Access Compliance Report

Public Rights-of-Way

(Curb Ramps)

Intersection ID: 4672	Main Street: W_MALLARD_CREEK_CHURCH_RD	Cross Street: SENATOR_ROYALL_DR	Location: NE
ADA ID: 49F765C72500	Ramp Type: IslandPerp	Initial Pass/Fail: Fail	Overall Compliance: No
Severity Score: 13.75			
Codes/Mitigation Info/Possible Solution		Field Measurements/Component Compliance

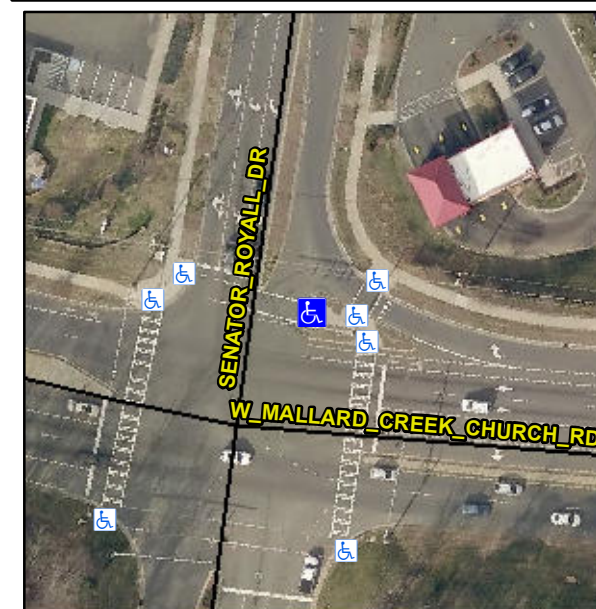
R304.2.2

Compliance	Description	Data	Compliance	Description	Data
N/A	Ramp Length (in)	131.5	No	Ramp Slope (%)	10.1
Yes	Ramp Width (in)	48.0	Yes	Ramp XSlope (%)	4.5
N/A	Flare Type LT	N/A	N/A	Flare Type RT	N/A
N/A	Flare Slope LT (%)	N/A	N/A	Flare Slope RT (%)	N/A
N/A	Flare Traversable LT?	N/A	N/A	Flare Traversable RT?	N/A
N/A	Landing Length (in)	N/A	N/A	DWS Provided?	N/A
N/A	Landing Width (in)	N/A	N/A	DWS Contrast?	N/A
N/A	Landing Slope (%)	N/A	N/A	DWS Length (in)	N/A
N/A	Landing X Slope (%)	N/A	N/A	DWS Full Width?	N/A
N/A	Landing Curb? (Y/N)	N/A	N/A	DWS Offset (in)	N/A
N/A	Shared Landing?	N/A			
N/A	Gutter Ponding?	N/A	N/A	Gutter Slope (%)	N/A
N/A	Gutter Lip Ht (in)	N/A	N/A	Gutter X Slope (%)	N/A
N/A	Painted X Walk1?	Yes	N/A	Painted X Walk2?	N/A
	X Walk 1 Direction	To NW		X Walk 2 Direction	N/A
N/A	X Walk 1 Width (in)	120.0	N/A	X Walk 2 Width (in)	N/A
	X Walk 1 Slope (%)	9.6		X Walk 2 Slope (%)	N/A
	X Walk 1 X Slope (%)	5.5		X Walk 2 X Slope (%)	N/A

Remove & Replace Entire Ramp.
